CODE: CC-293

DATE: DECEMBER 21, 1994

SUBJECT: SERIES 2000 SNOWTHROWERS MODEL 190-303

703-2728  
LIFT HANDLE LATCH BRACKET  
FIG. 1

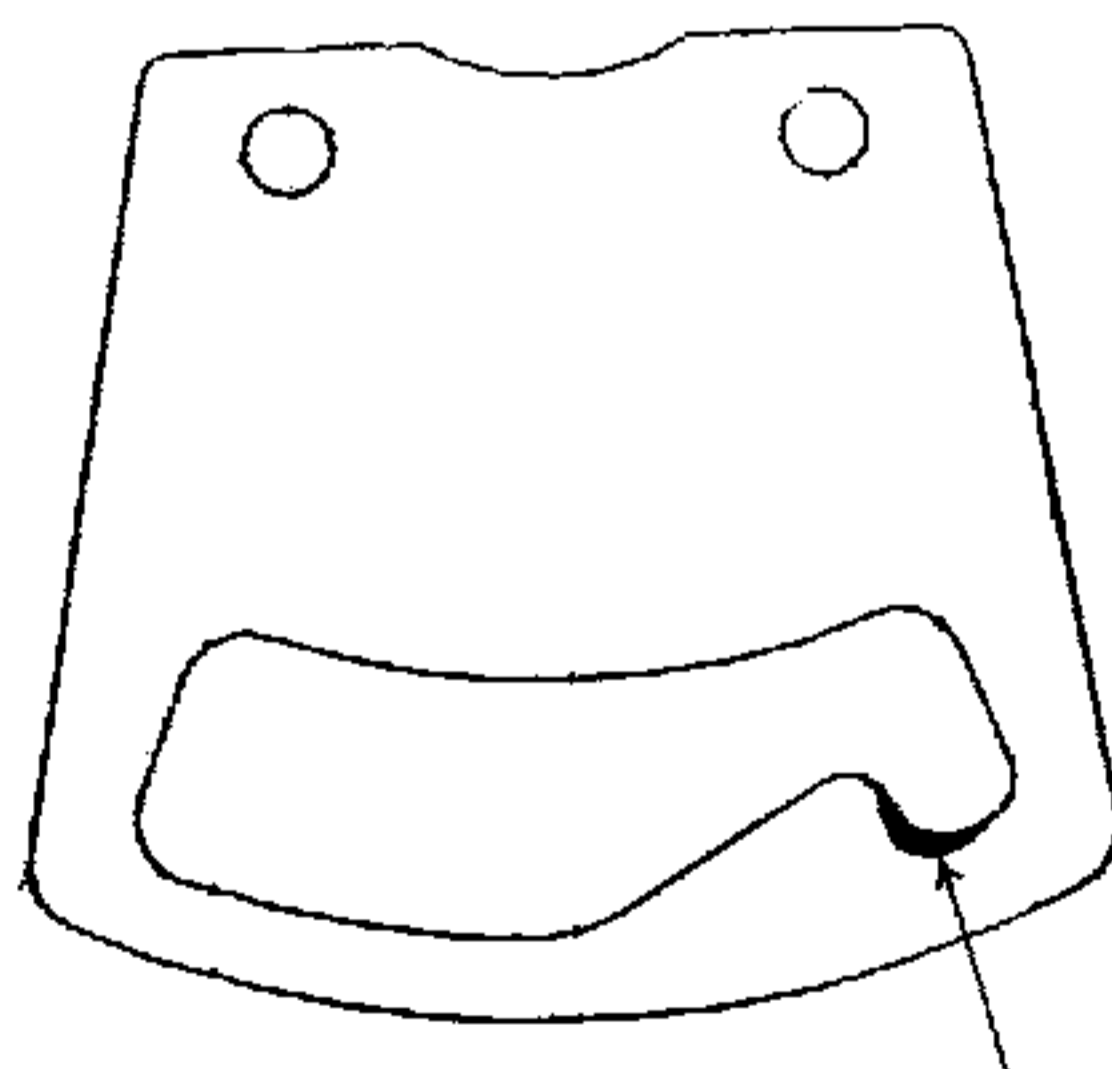
**PROBLEM:** WE HAVE RECEIVED SOME REPORTS FROM THE FIELD OF THE 303 SNOWTHROWERS WHEN IN THE RAISED POSITION, THE LIFT LATCH ROD IS NOT ENGAGED COMPLETELY INTO THE LIFT HANDLE LATCH BRACKET(#703-2728), ALLOWING THE SNOWTHROWER TO BECOME DISENGAGED AND DROP TO THE GROUND.

GRIND HERE

**SOLUTION:** REMOVE THE LIFT HANDLE LATCH BRACKET AND GRIND OUT THE SHADED IN AREA SHOWN IN FIG. 1 BELOW. THIS WILL ALLOW THE LIFT LATCH ROD TO HAVE BETTER ENGAGEMENT.
